December 16, 2022
Project No. 0771-368-11-123

Re: Response to Technical Notice of Deficiency Letter – Type I Major Amendment
Application
Turkey Creek Landfill
Alvarado, Johnson County, Texas
MSW Permit No. 1417D
RN100825462/CN601668486
Tracking No. 27341370

ATTACHMENT 1
APPLICATION DEFICIENCIES TABLE

Drawing I/IIC-1	Buffer Zone Plan	I/IIC-4
Drawing I/IIC-2	Regional Tectonic Map	I/IIC-12
Drawing I/IIC-3	Regional Lineament Map	I/IIC-13
Drawing I/IIC-4	Seismic Impact Zone Map	I/IIC-15

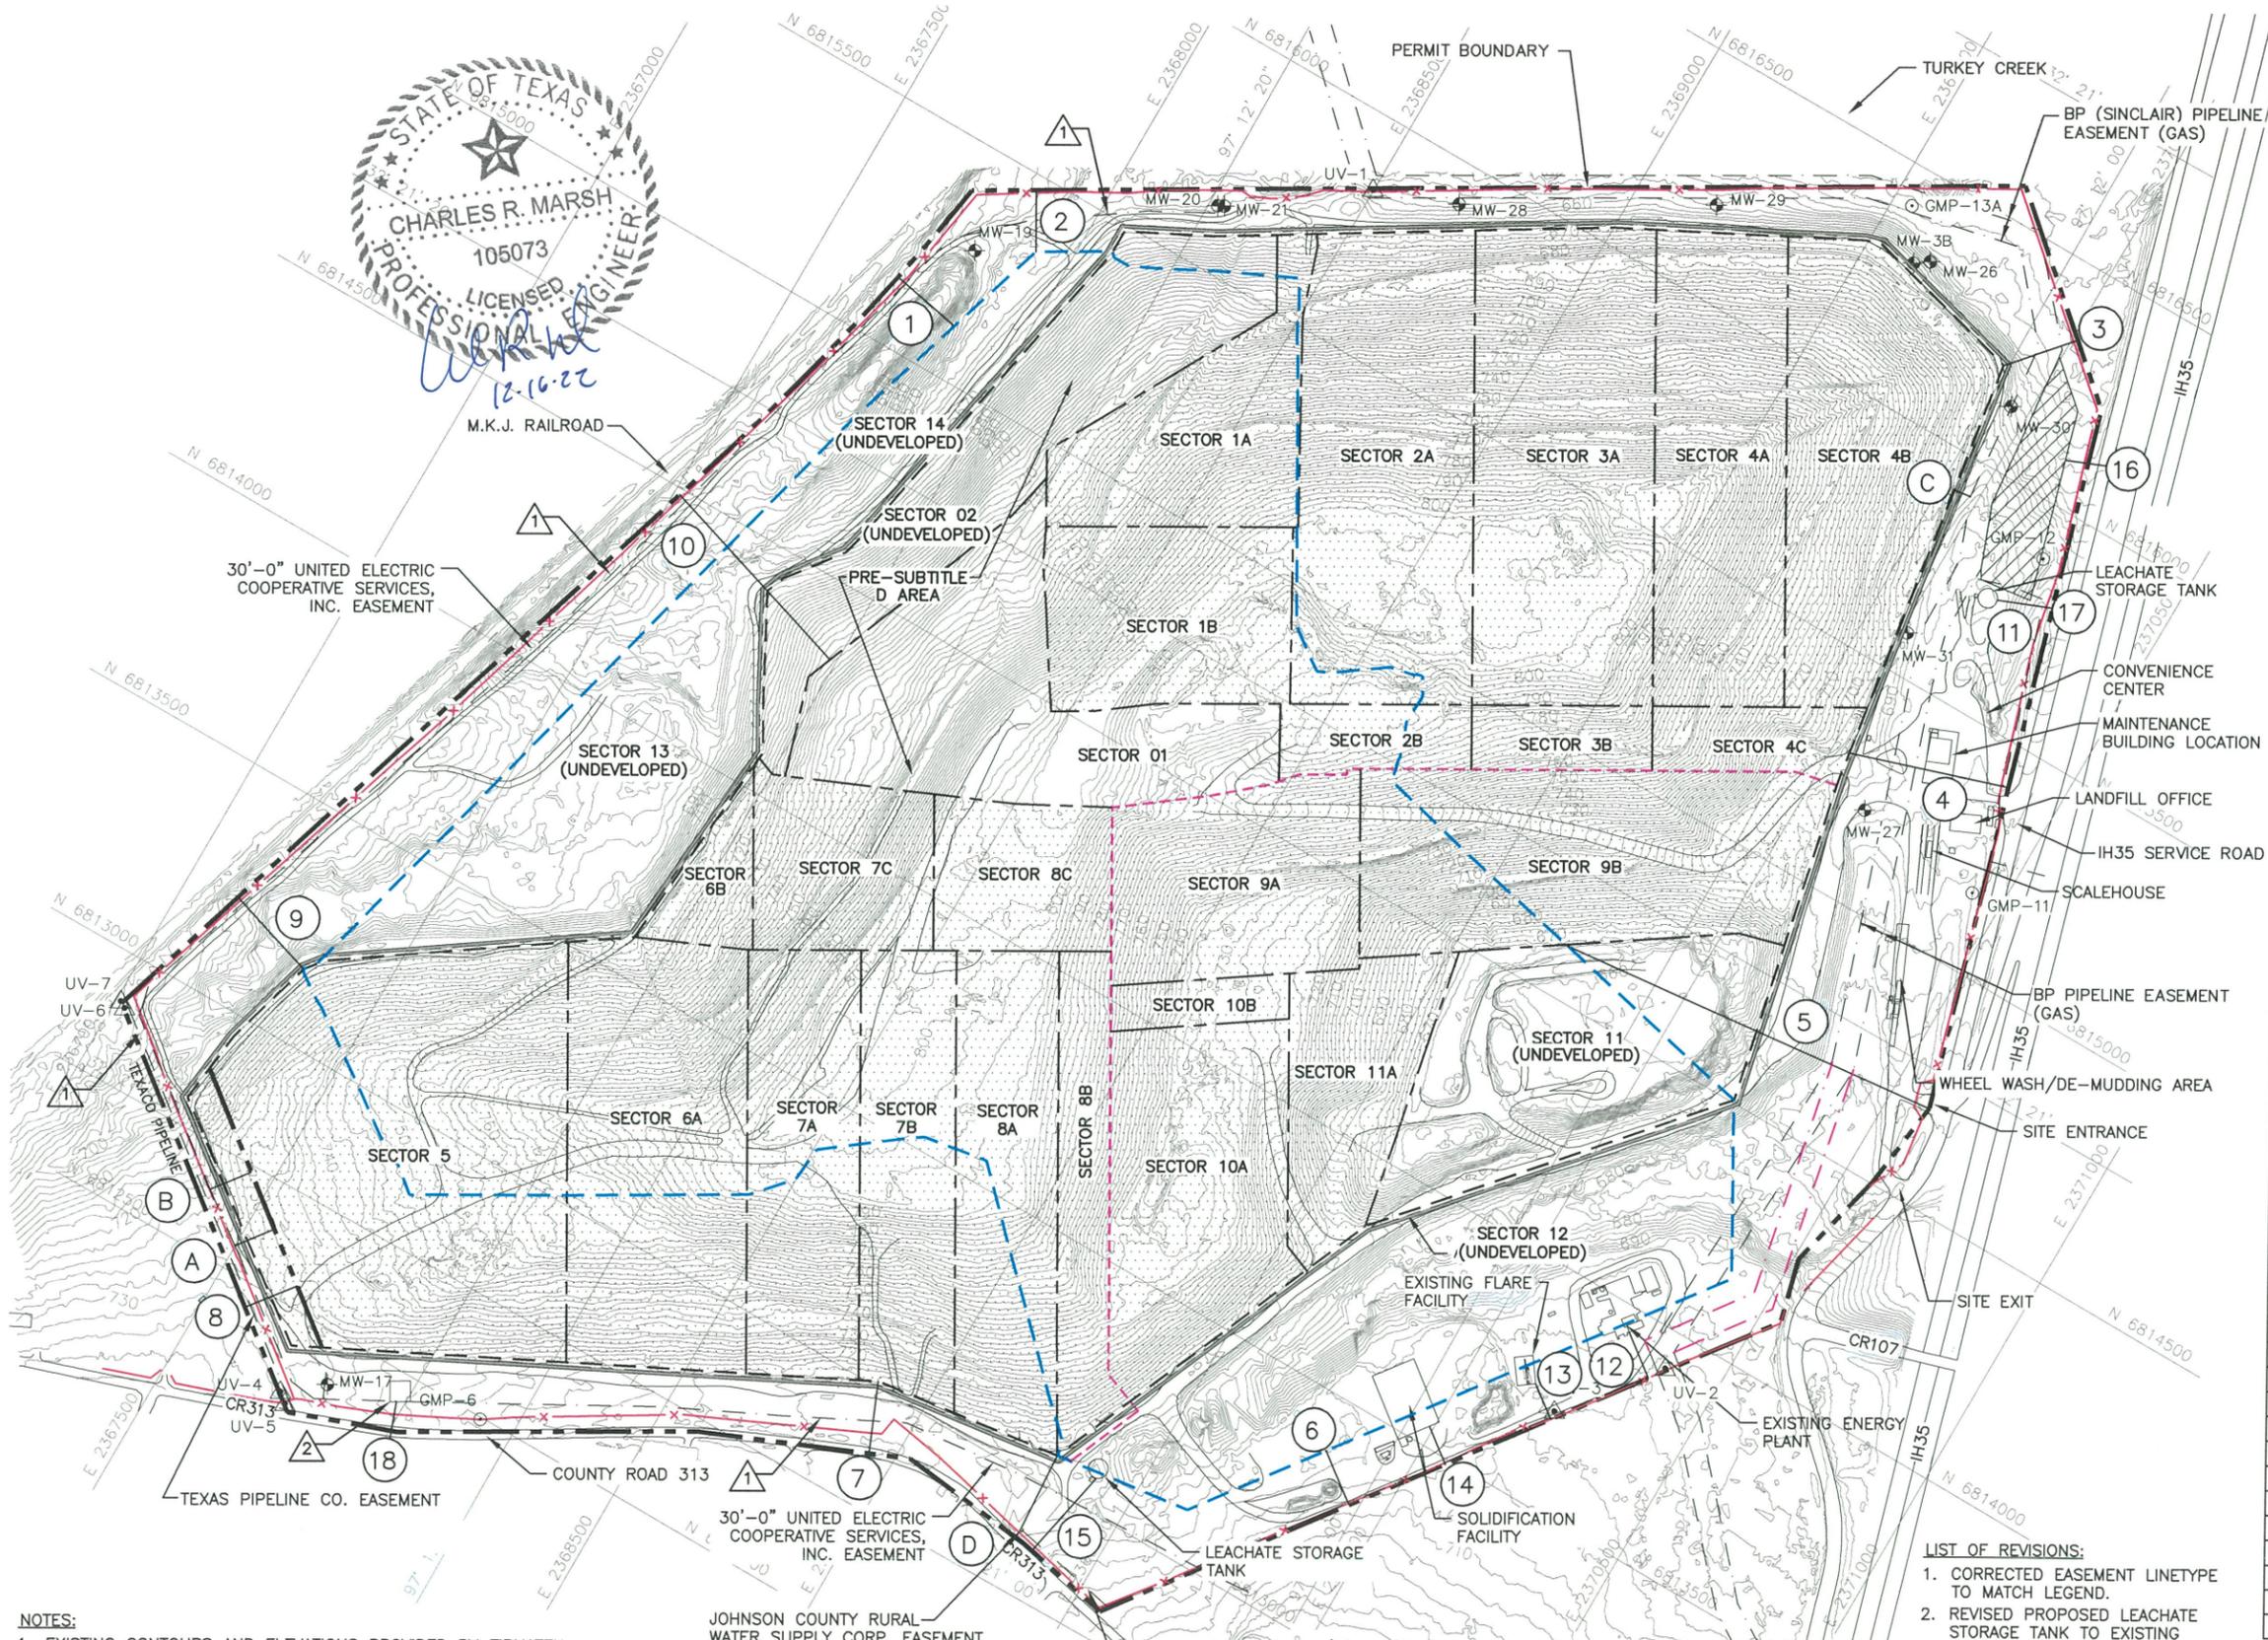
NT10	10	182	Part II	330.61(c)(10)	Volume 1 - Parts I/II - Appendix I/IIIC - Section 2	NT	Ambiguous	Revise Drawing I/IIIC-1 to use correct symbol for all easements. Response: Drawing I/IIIC-1 has been revised to correct the line type designating easements.
NT11	11	213	Part II	330.547(b)		NT	Incomplete	Provide response from FEMA regarding the site's CLOMR request once received. Response: A response from FEMA on the CLOMR has not been received as of the time of this response and will be provided to TCEQ upon receipt.
